CITY OF ALBUQUERQUE

**RE: Mark 3S Holly Development
9300 Holly NE
Grading and Drainage Plan
Engineer's Stamp Date 1/30/18 (File: C20D062)**

Based on the information provided in your submittal received on 1/31/18, this plan cannot be approved until the following are corrected:

GRADING AND DRAINAGE PLAN MARK 3S HOLLY DEVELOPMENT

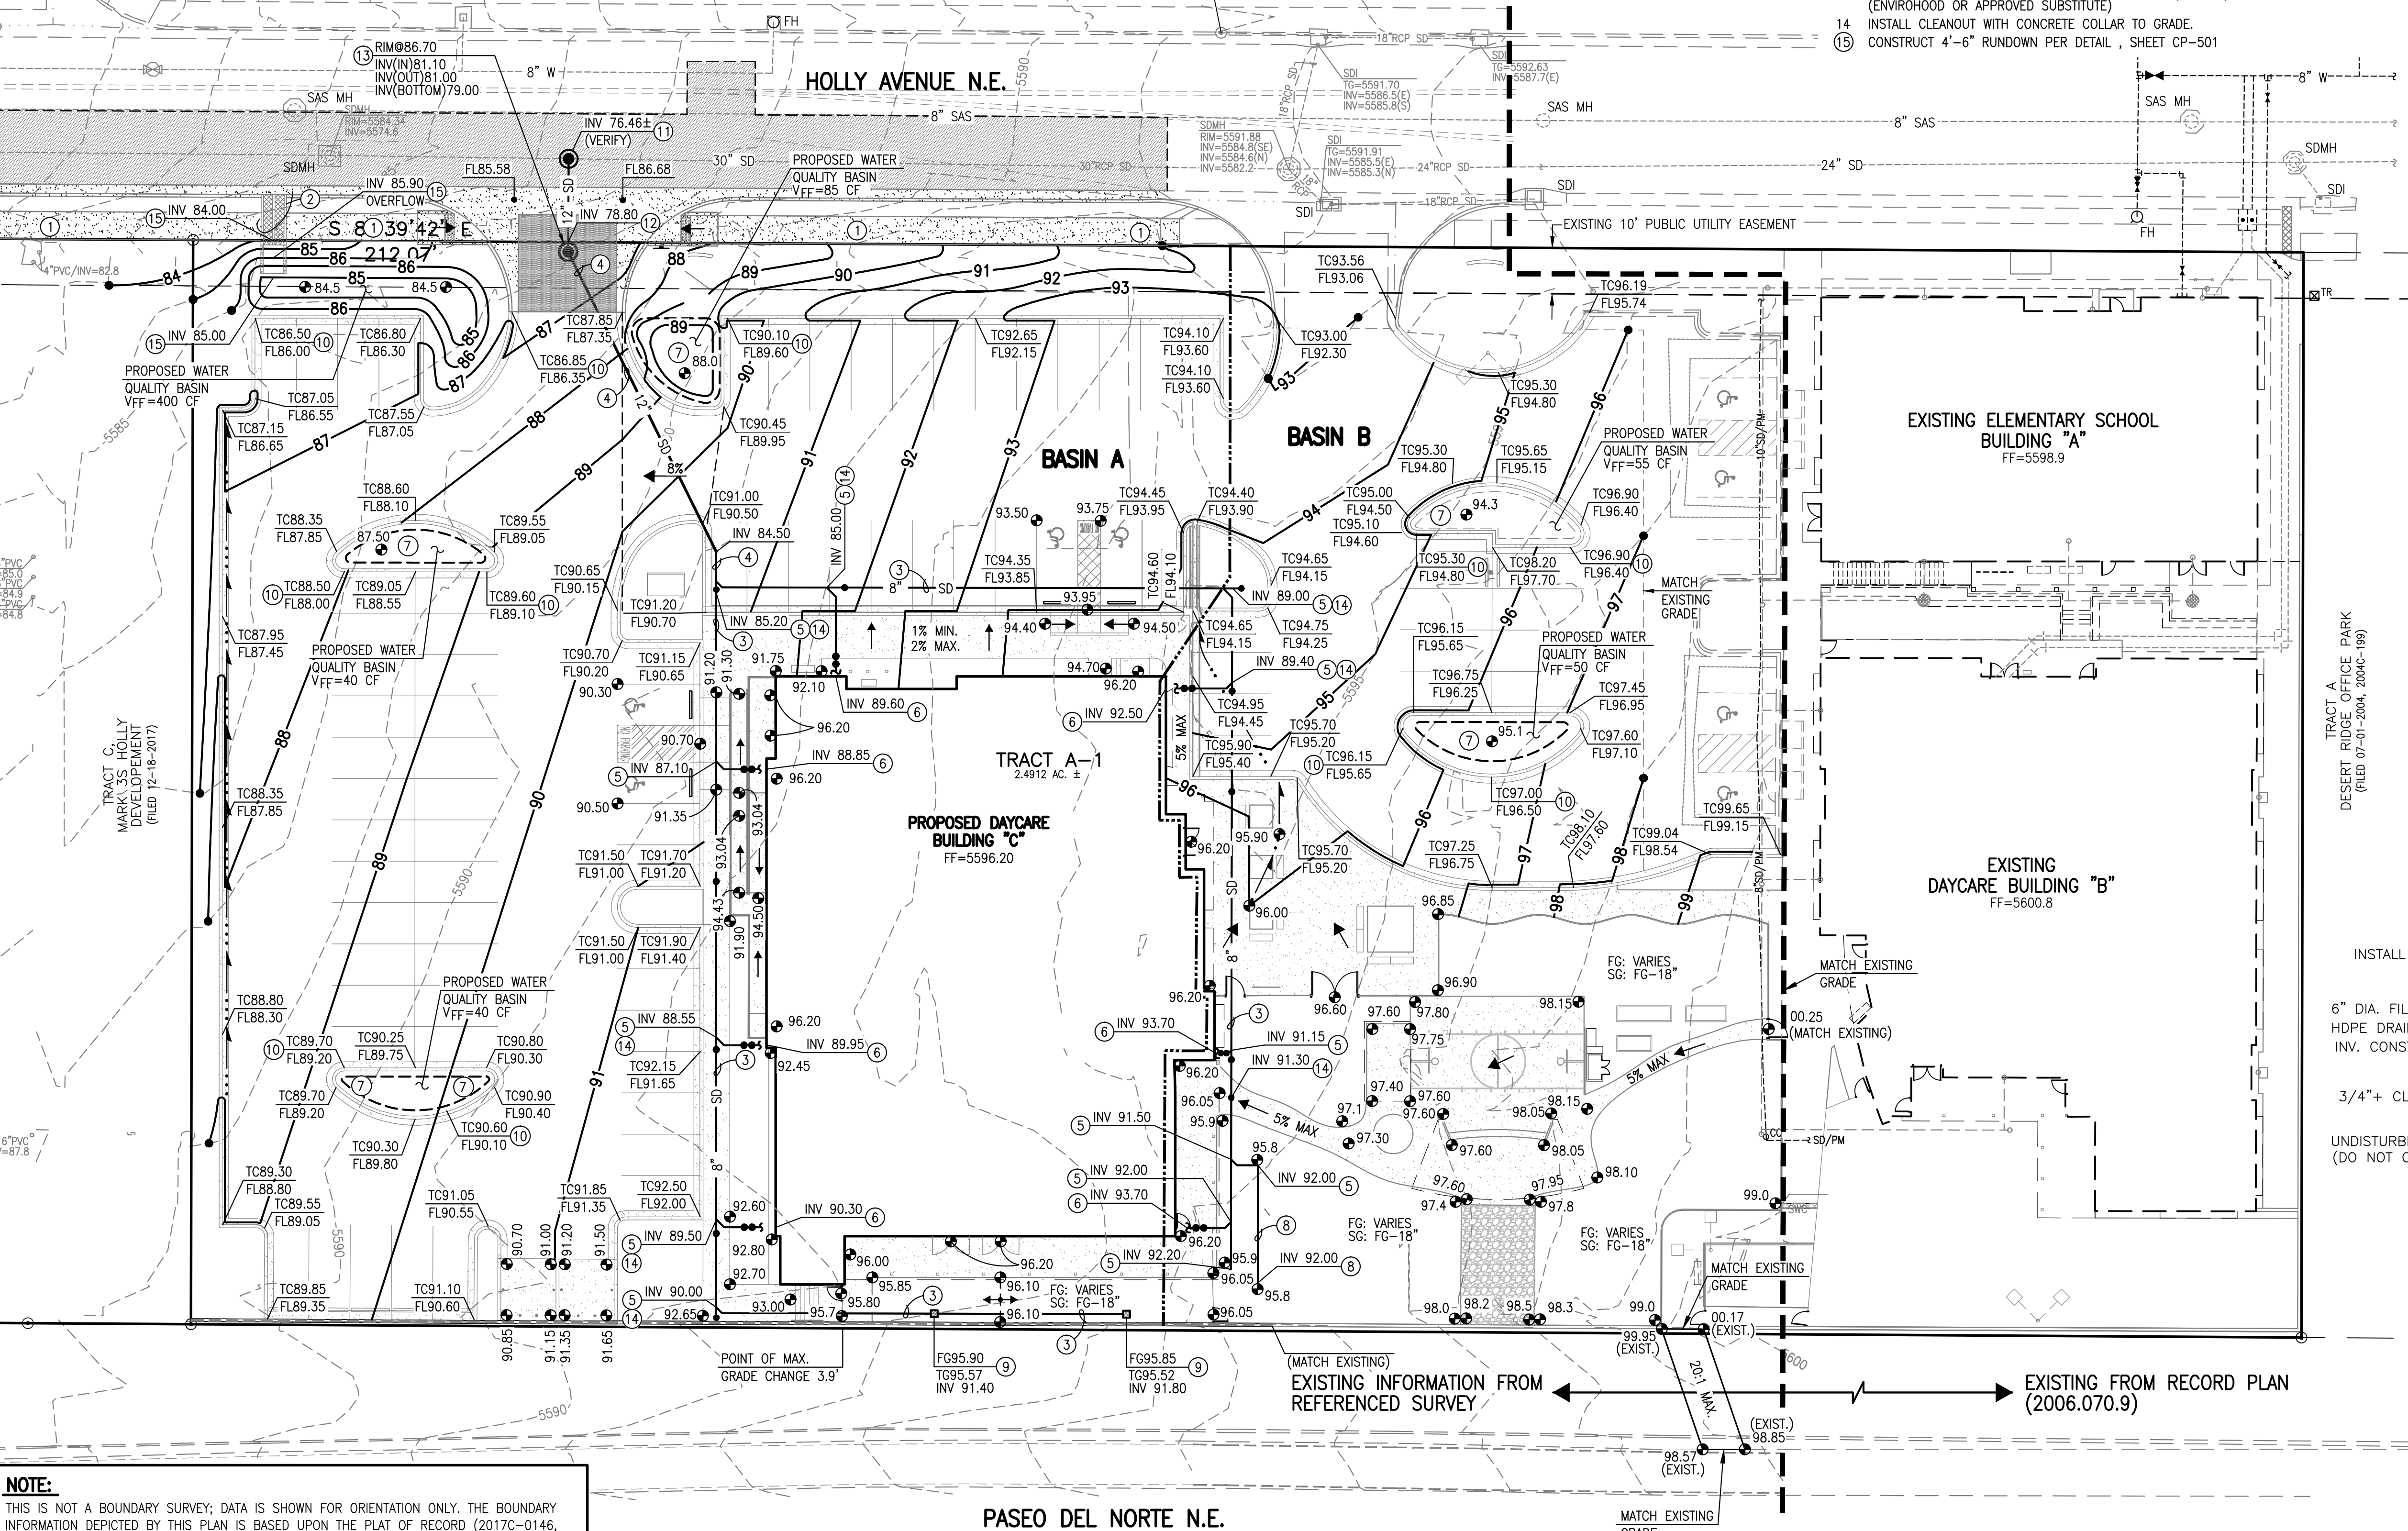
1. Provide a subbasin delineation map showing the area draining to each first flush pond. Quantify impervious v. pervious area.
2. Each pond needs to be sized for the impervious area draining to it.
3. For redevelopment, the first flush requirement is calculated as: $\text{Volume} = 0.26'' \times \text{Rebuilt Impervious Area}$. The rebuilt impervious area is the impervious area for the new school expansion, plus the impervious area of repaved parking lot/play area at the existing school.
4. The storm drain connection in the Public ROW needs to be 18" min. RCP class 3. Also add a Public/Private divide line at the new private manhole.
5. Provide a detail for the new retaining wall adjacent to Paseo del Norte ROW. Demonstrate that the adjacent ROW is not damaged or constrained in its use by the new wall.

TYPICAL PERFORATED PIPE SECTION

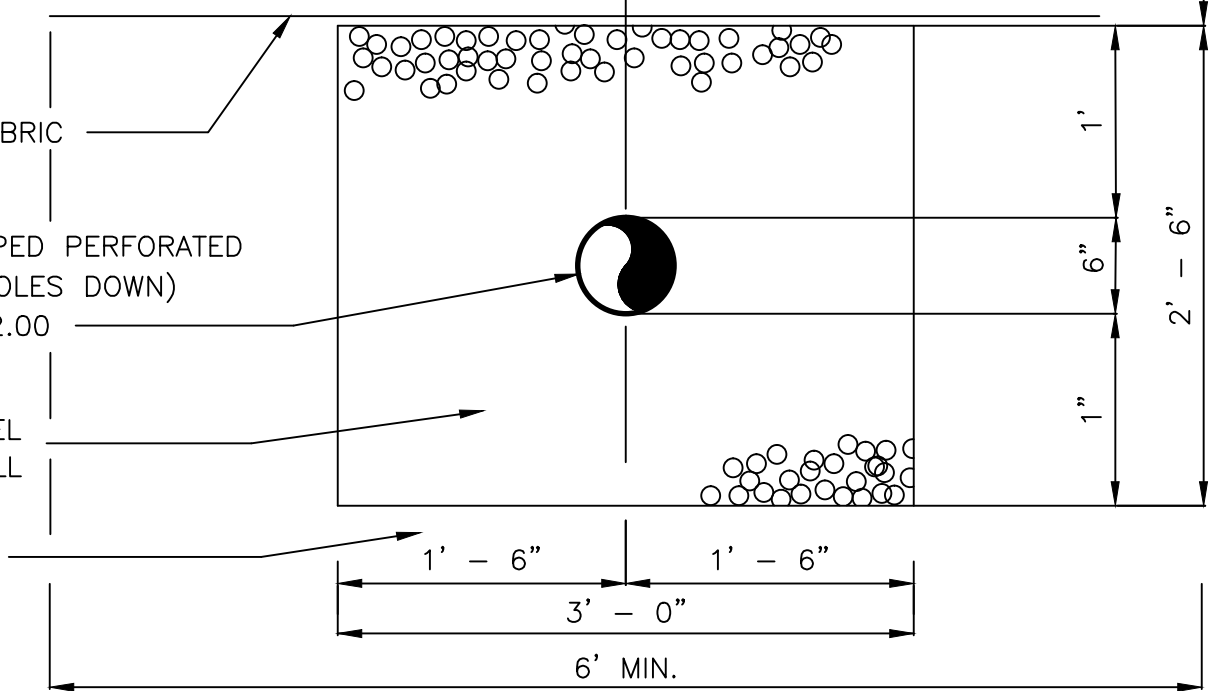
6. A Private Facility Drainage Covenant is required for the stormwater quality ponds. The original notarized form, exhibit A (legible on 8.5x11 paper), and recording fee (\$25, payable to City of Albuquerque) must be turned into DRC (4th, Plaza del Sol) for routing. Please contact Charlotte LaBadie (clabadie@cabq.gov, 924-3996) or Madeline Carruthers (mtafoya@cabq.gov, 924-3997) regarding the routing and recording process for covenants.
7. Correct the depth of gravel under the perforated pipe (1' vs 1").
